**Drain:** SARAH MORGAN **Drain #:** 143  
**Improvement/Arm:** HEATHER POINTE RELOCATION  
**Operator:** J. LIVINGSTON **Date:** 4-22-04  
**Drain Classification:** Urban/Rural **Year Installed:** 1995

Re: Sarah Morgan Drain - Heather Pointe  
Relocation

Project: Sarah Morgan - Heather Pointe Relocation

**SITE DEVELOPMENT PLAN**  
**HEATHER POINTE - SECTION ONE**  
PARCEL 22 - HAMILTON PROPER  
FISHERS, INDIANA

AS-BUILT 01/13/97

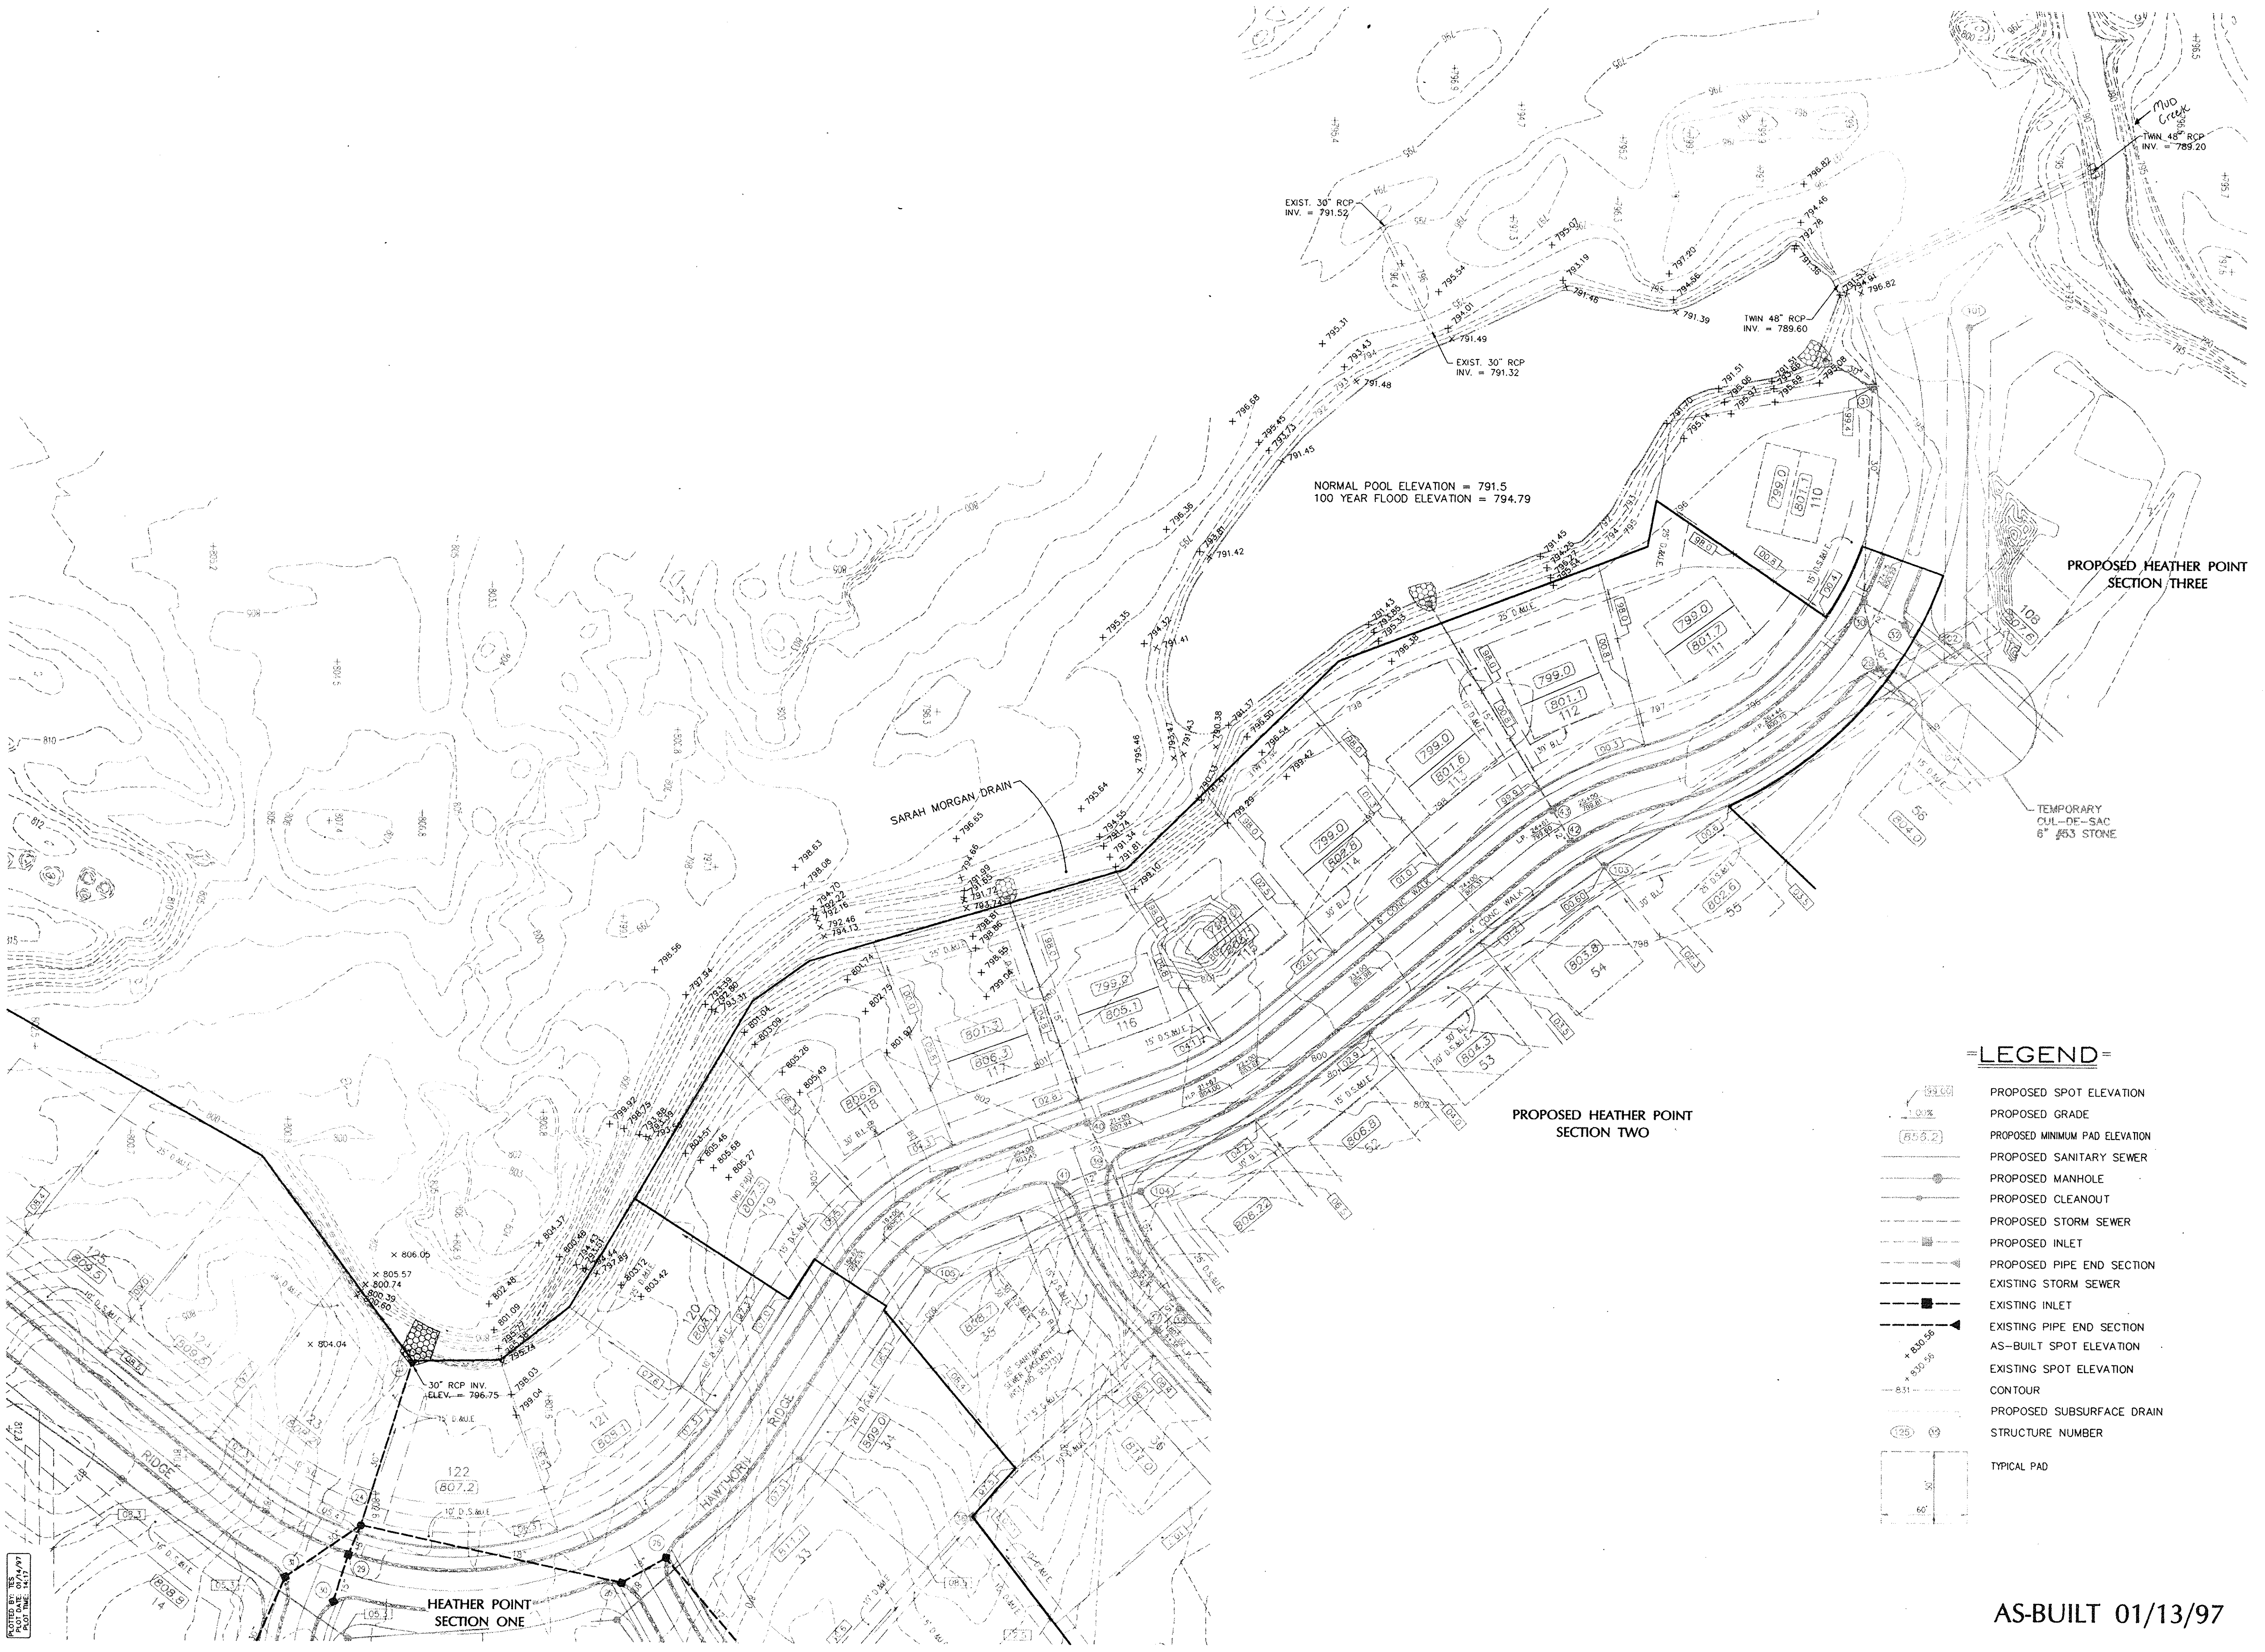
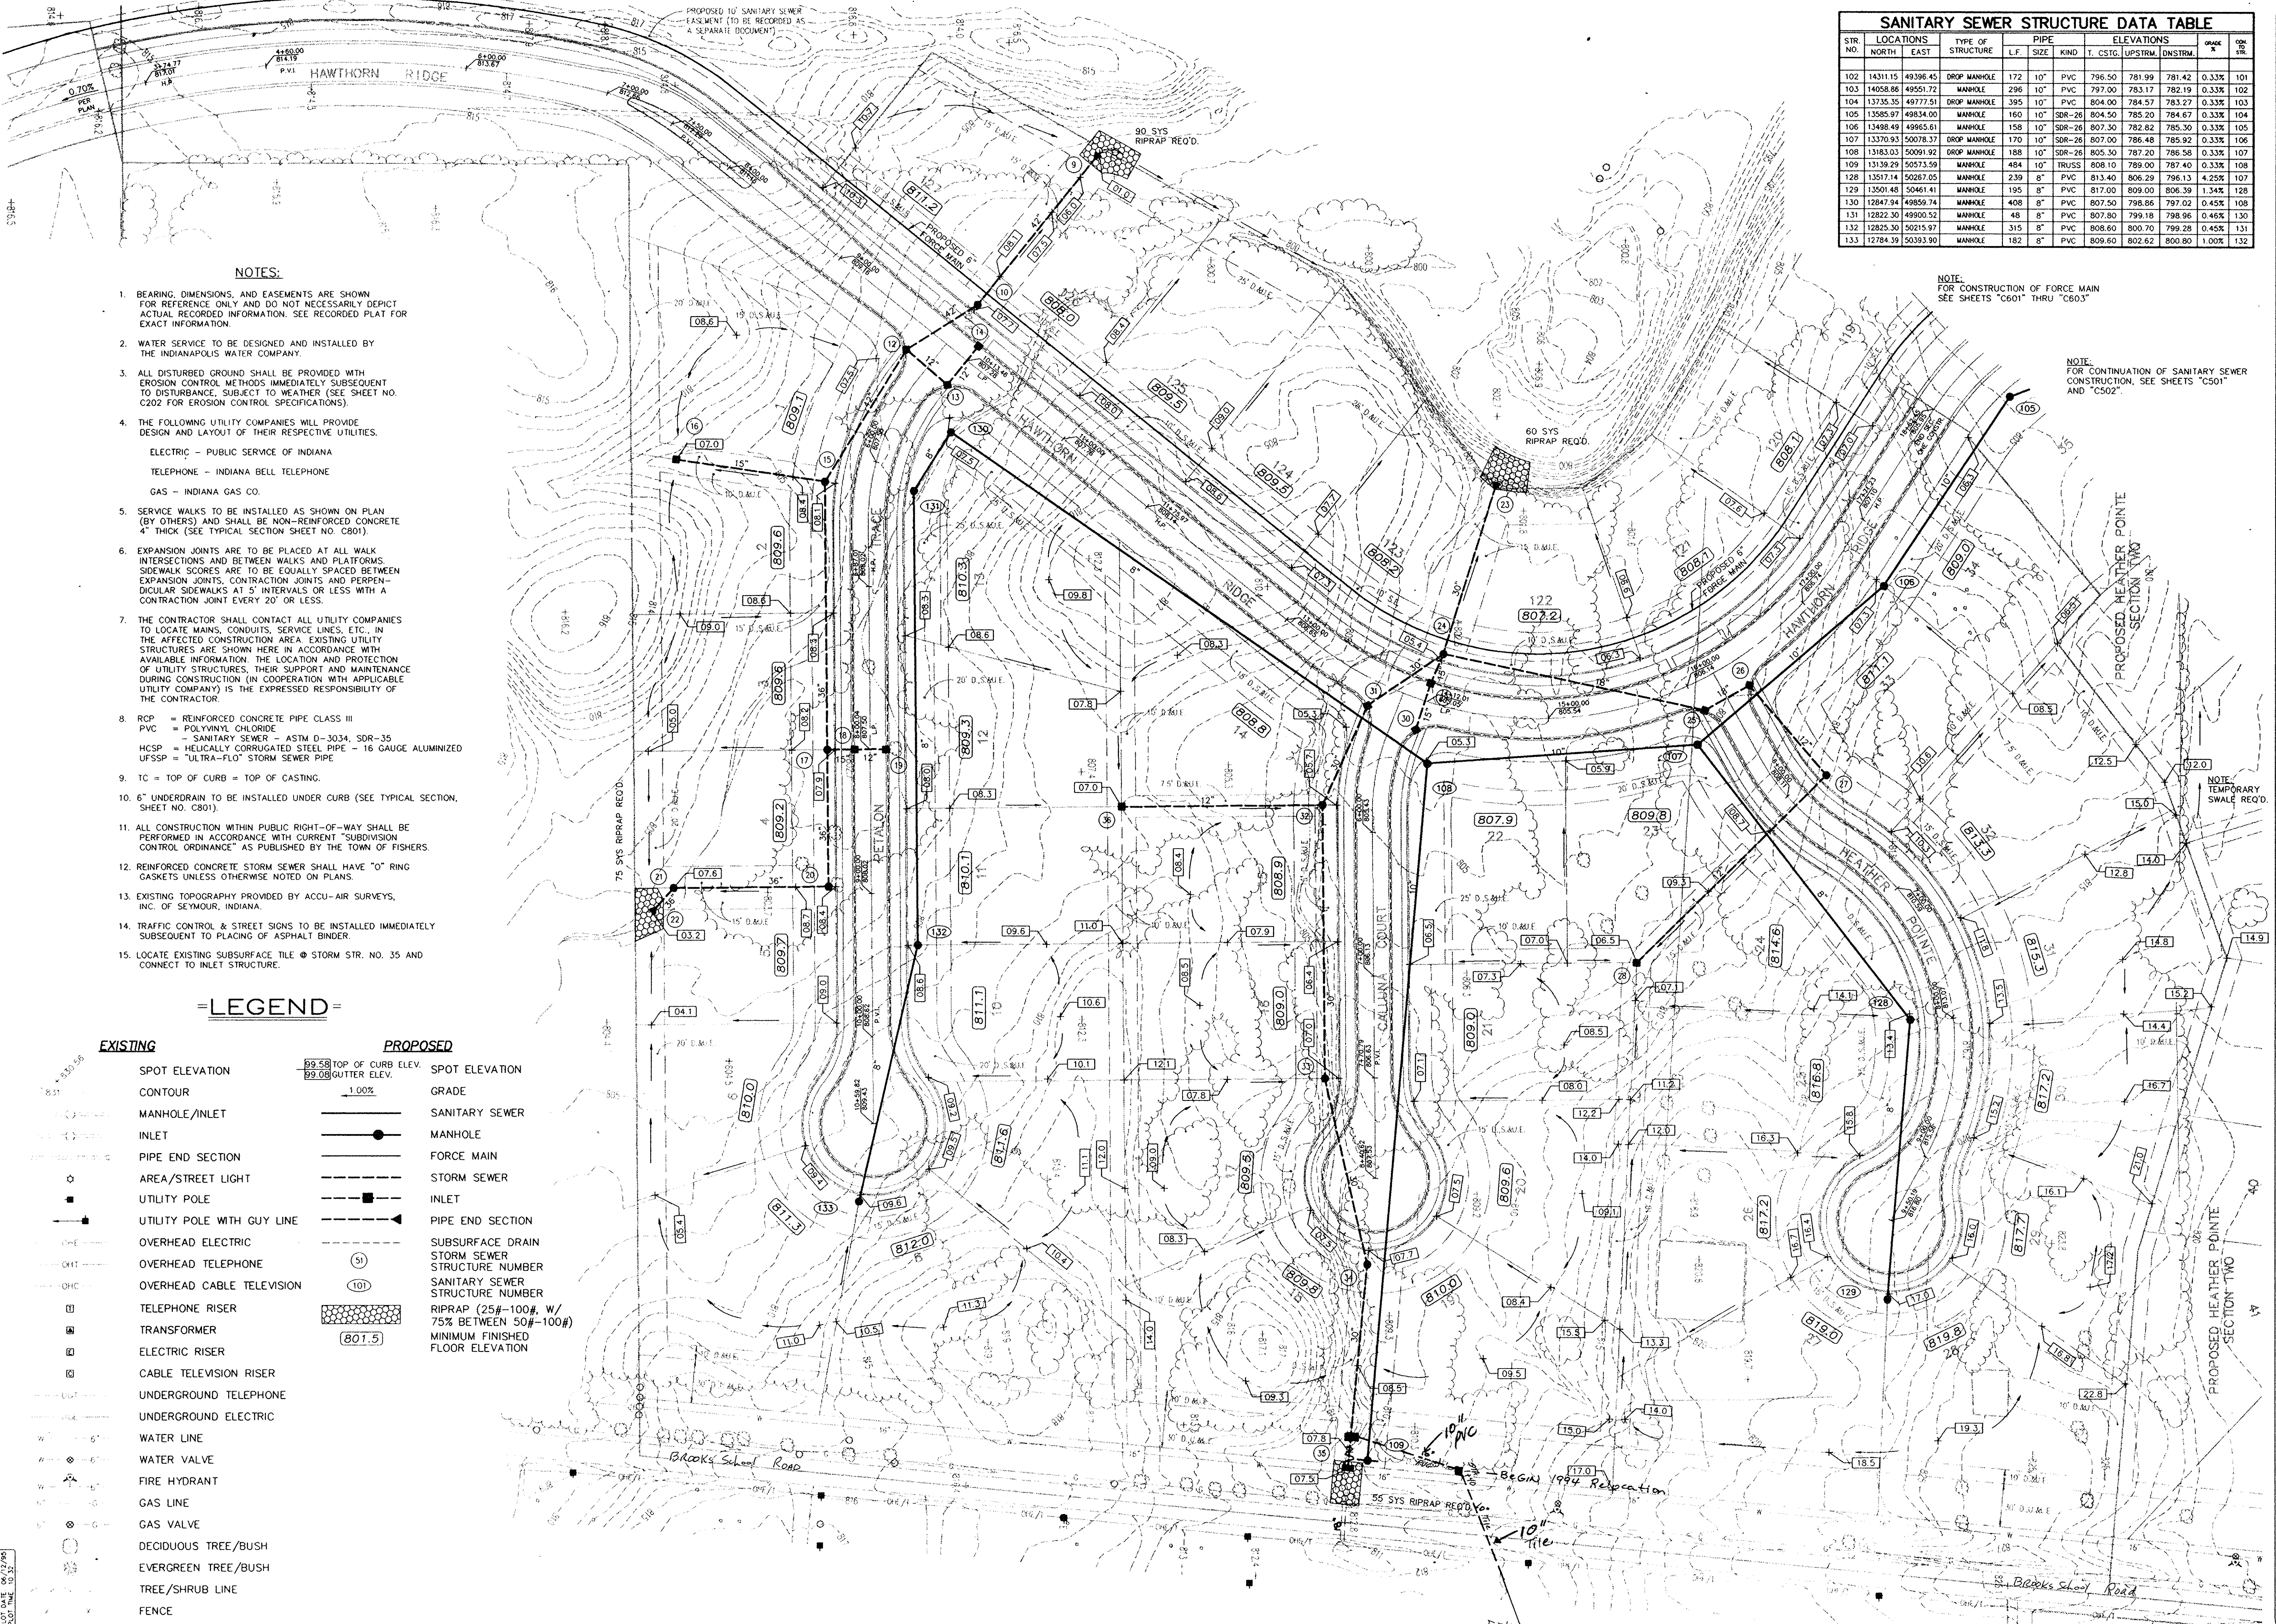
During construction, changes were made to the drain which will alter the plans submitted with my report for this drain dated August 22, 1994. The changes are as follows:

Str 24 - Str 31 30" RCP lengthened from 64' feet to 66' feet.

Str 31 - Str 32 30" RCP shortened from 75' feet to 73' feet.

Str 33 - Str 34 30" RCP lengthened from 133' feet to 135' feet.

Str 34 - Str 35 30" RCP shortened from 140' feet to 125' feet.

There was an inlet set on the existing Sarah Morgan Drain at Station 1+40 and from this structure 76' feet of 10" PVC was installed to structure 35.

The length of the drain, including the original 140 feet of drain, and the changes described above is now **1,835 feet**.
